Objection to retrospective planning application for replacement of the front hardstanding to 251 Goldhurst Terrace.

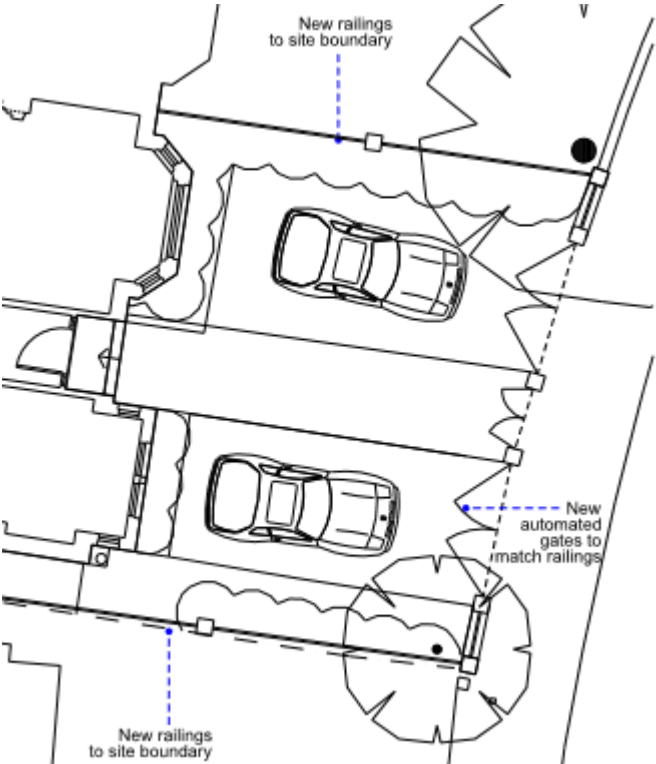
The 'Heritage Statement' shows (on pages 10 (photo 1) and 11 (figure 1)) two pictures of the 'front garden' before both the cellar/lightwells were built, and the new hardstanding was constructed.

Unlike those two pictures in the 'Heritage Statement', the current 'front garden' has no soft-landscaping or planted vegetation whatsoever, except for about 0.5 sqm of bare soil around the tree at the very front left of the boundary (visible in the bottom-left picture on the final page).

Above: The new hardstanding in the 'front garden' appears to allow for no planting or soft-landscaping around its perimeter, unlike the hardstanding that it has replaced (see picture below). It is also not clear how/where the new hardstanding drains to (no evidence of a soakaway drain?), and there appears to be no differentiated central 'path' to the front door.

Above: The previous hardstanding allowed a generous margin on three sides for hedges (on either side) and large, attractive shrubs (in beds in front of the two bay windows near the house).

Above: An extract from application 2019/4236/P (for the installation of the front railings, gates and brick piers to the front) showing the then-existing (and proposed to be retained for that application) soft landscaping and generous/wide vegetation along each side boundary of the hardstanding area and in front of both the bay window structures. (Note: although this application substantially post-dates the earlier 2016 application for a large basement excavation including two large front lightwells, it does not appear to show the lightwells that were a part of the earlier application).

Why has all the soft-landscaping and substantially-sized greenery been removed and with no stated intention to re-instate the hedges or the large shrubs in front of the bay structures? Note, the above diagram also shows some sort of 'path' between pavement and the front door, that is suitably differentiated in its surface treatment from the block/brick paving used for the hardstandings on either side. This was indeed a feature of the previous hardstanding, now removed, but seemingly this feature has not been replicated in the new version?

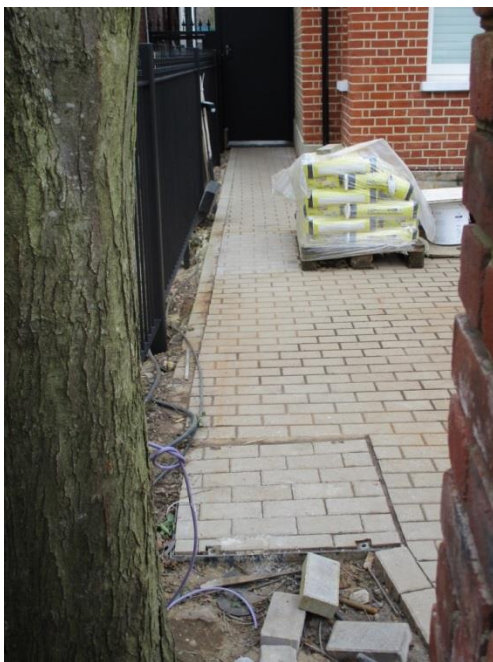
Above: The two extracts above are from plans/elevations provided with application 2016/6697/P (excavation of large basement with two front lightwells) and clearly show the intended re-planting of some small shrubs to the front of the house adjacent to the edge of the lightwell. This has not yet been done, and the paved area of the new hardstanding has encroached into the proposed planting area, and needs to be trimmed back by around 50—60cm from the lightwells in order to allow for this shrub planting.

Above: View of front garden in 2016 showing the former extensive hedges on both left and right-hand boundaries of the former hardstanding, as well as extensive tall shrubs and even a small palm-like tree in front of the left and right-hand bay window structures. None of this vegetation and soft-landscaping is present now (all was presumably removed when the basement was excavated) and should be required to

The three pictures above (taken in early March 2024) show the current replacement hardstanding in the 'front garden'.

The top picture shows no differentiation in surface treatment between the two parking spaces and the central path to the front door. This differentiation is clearly visible in the previous version of the hardstanding- please see the earlier pictures of the old hardstanding where cobbles define the parking spaces and larger block paving stones define the path. It also shows that no space has been left for soft-landscaping/re-planting adjacent to the two lightwells. This needs to be created by removal of a band of some 50-60cm of paving around the lightwells with re-planting to follow.

The bottom left picture shows the left-hand boundary with the new paving bricks/blocks coming right up to the fence on the boundary, with no room for a replacement hedge to be successfully planted. The bottom right picture shows the same lack of space for successful planting of a hedge on the right-hand-side boundary. Soft-landscaping space on both sides needs to be created by removal of a band of some 50-60cm of paving blocks on each side, with hedge re-planting to follow.

be re-instated so as to improve the visual amenity of the 'front garden' and comply with the key SHCA characteristics in the CA Appraisal document, and improve absorption of heavy rainwater run-off.
